HISTORIC AND DESIGN REVIEW COMMISSION

HDRC CASE NO: 2025-089
ADDRESS: 849 E COMMERCE ST
LEGAL DESCRIPTION: NCB 151 LOT 3, A1,A2,A3,A4,A5,A6,7,8,60,61, 62,63,65,A66 & 64 EXC SW 32 FT (2.533 AC) & NCB 1010 BLK 2 LOT 26 (.99 AC), 28 (1.44 AC), 31 (.71 AC) & PT OF LOT 30 (5.11 AC)
ZONING: D, RIO-3
CITY COUNCIL DIST.: 1
APPLICANT: Amanda Perez/Protection Development Inc.
OWNER: NEW RIVERCENTER MALL II LP
TYPE OF WORK: Construction of a covered patio and ADA ramp at the Rivercenter Mall Lagoon
APPLICATION RECEIVED: March 28, 2025
60-DAY REVIEW: May 27, 2025
CASE MANAGER: Edward Hall

The applicant is requesting a Certificate of Appropriateness for approval to construct a new ramp and covered patio within the lagoon at 849 E Commerce, Rivercenter Mall. The proposed new construction will include the removal of existing, non-ADA compliant elements.

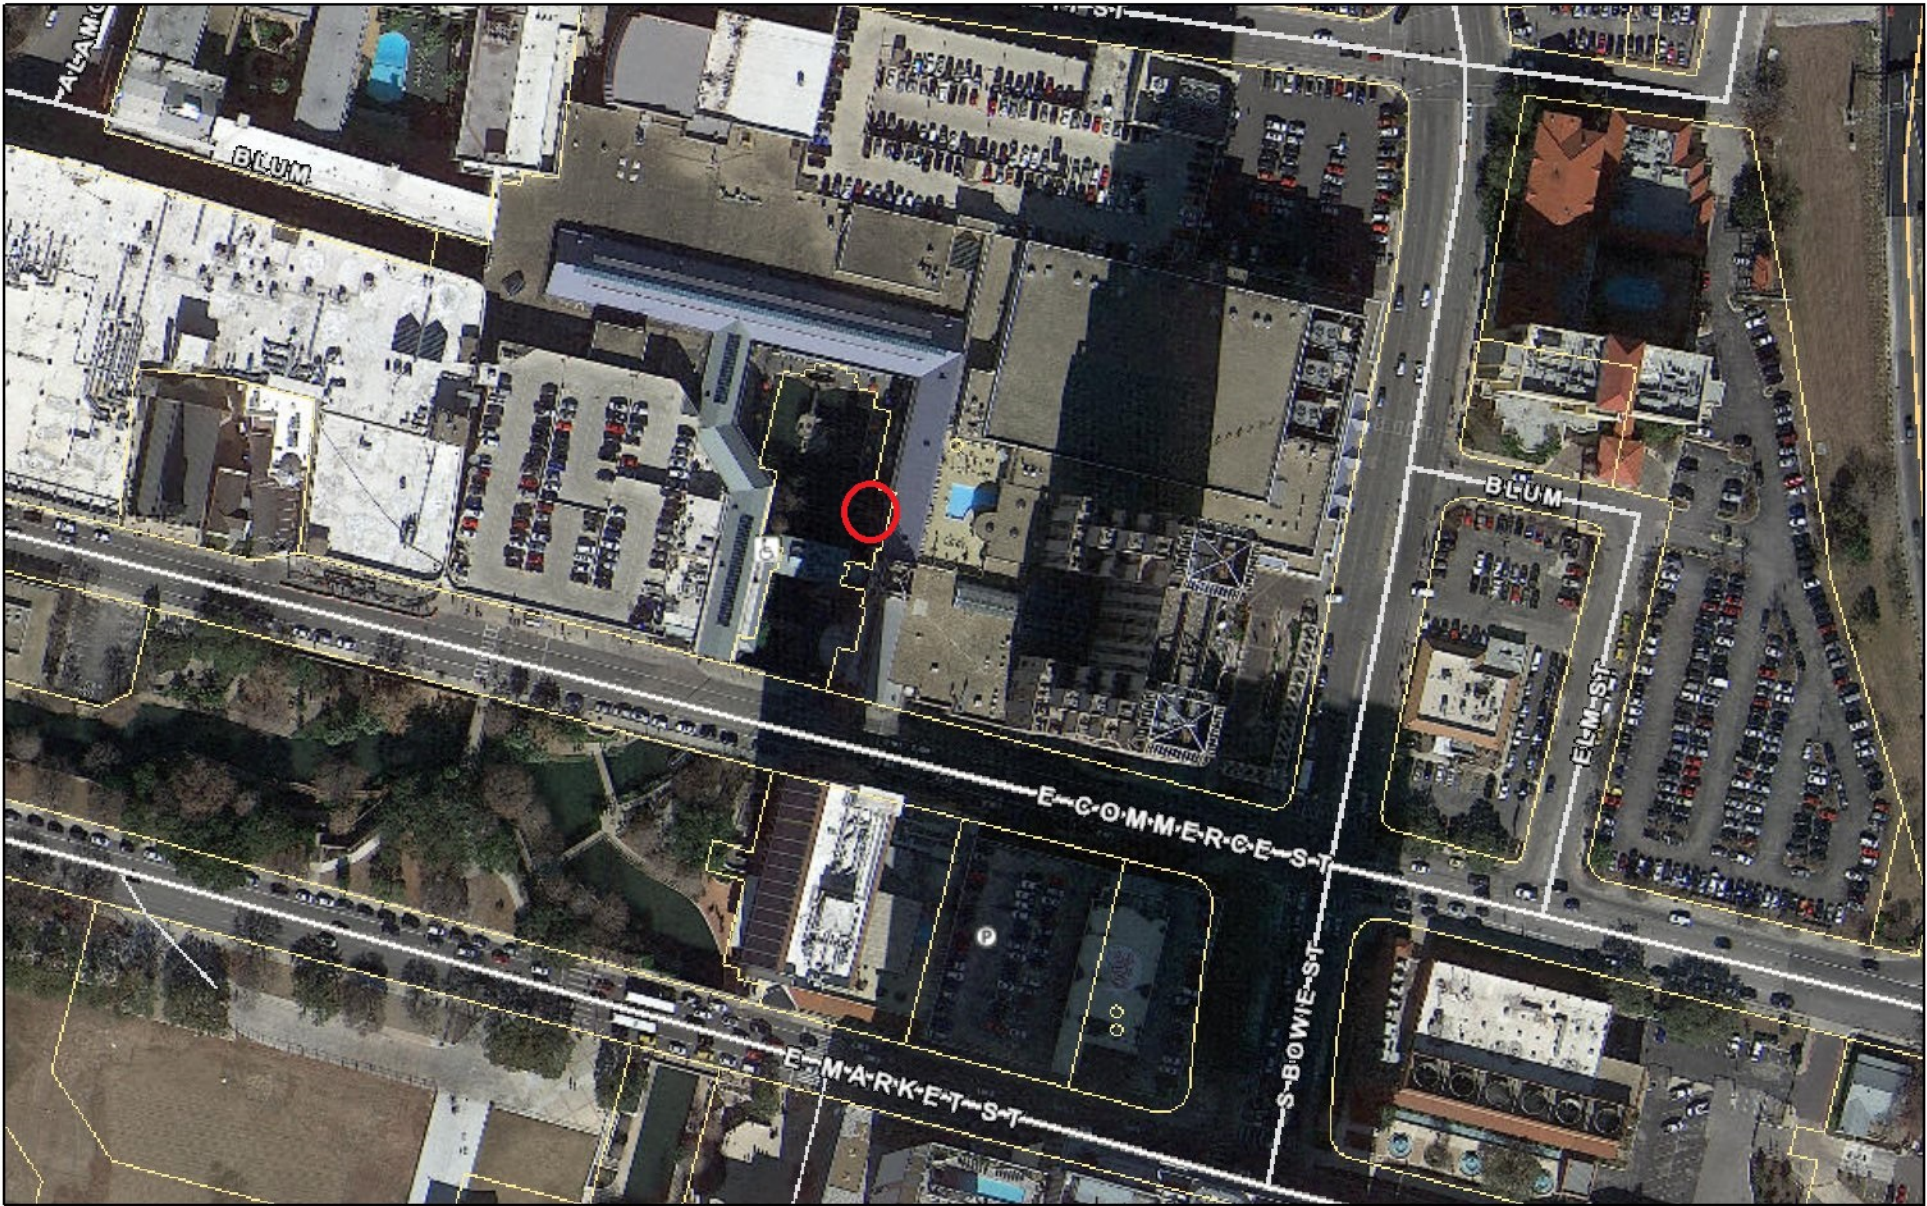
- b. DESIGN & MATERIALS – The applicant has proposed to remove the curved ramp and install an ADA compliant ramp, as well as a new raised and covered patio. The applicant has proposed materials that include limestone clad walls to match the existing on site, metal railings to match the existing on site and a metal roof structure. The proposed ramp and covered patio element will also include the removal of existing planter walls. These walls are not historic in nature. Staff finds the proposed ramp and covered patio to be appropriate and consistent with the UDC.

- c. LANDSCAPING – The proposed ramp and covered patio construction will require the removal of two existing cedar elms trees. The applicant is responsible for coordinating all tree work with the City Arborist.

- d. LANDSCAPING – The applicant has noted the installation of plantings within the project level. Staff finds this to be appropriate and consistent with the UDC; however, staff finds that a details landscaping plan should be submitted to OHP staff for review and approval.

Staff recommends approval based on findings a through d with the following stipulations:

- i. That a detailed landscaping plan be submitted to OHP staff for review and approval.
